<b>Docket Number:</b>	00-AFC-02C
<b>Project Title:</b>	Mountainview Power Plant - Compliance
<b>TN #:</b>	220661
<b>Document Title:</b>	Mountainview Generating Station - carbon monoxide control catalysts replacement
<b>Description:</b>	Petition to replace CO air pollution emissions control catalysts
<b>Filer:</b>	Patty Paul
<b>Organization:</b>	Southern California Edison
<b>Submitter Role:</b>	Applicant
<b>Submission Date:</b>	8/11/2017 9:10:47 AM
<b>Docketed Date:</b>	8/11/2017

**RE: MOUNTAINVIEW GENERATING STATION (Docket No. 00-AFC-2)  
Petition for Staff Approved Modification to Carbon Monoxide Catalyst  
Replacements**

**PETITION FOR A STAFF APPROVED MODIFICATION**  
**TO REPLACE FOUR CARBON MONOXIDE CATALYSTS DURING REGULARLY**  
**SCHEDULED FALL (2017)**  
**PLANT MAINTENANCE OUTAGES**

**Figure 4**

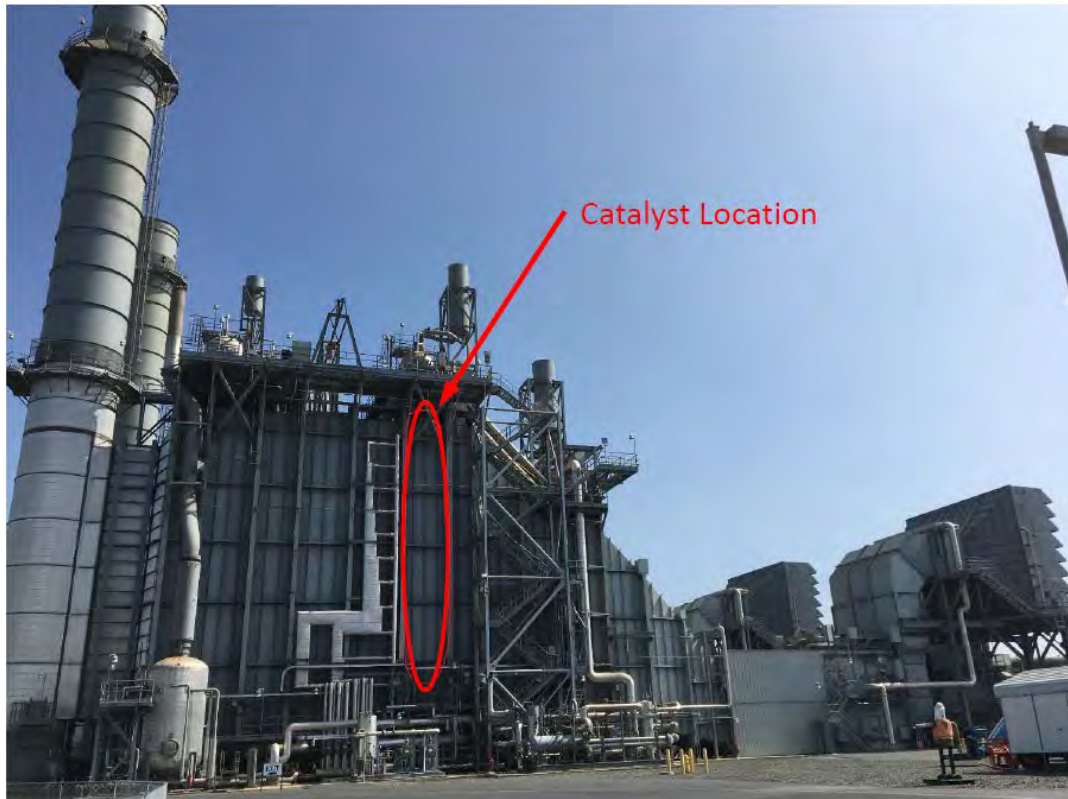
The proposed modifications will not change the external physical appearance of the affected equipment. The modifications are internal to the combustion turbine exhaust duct which is

self-contained, as shown in Figure 4 (below).
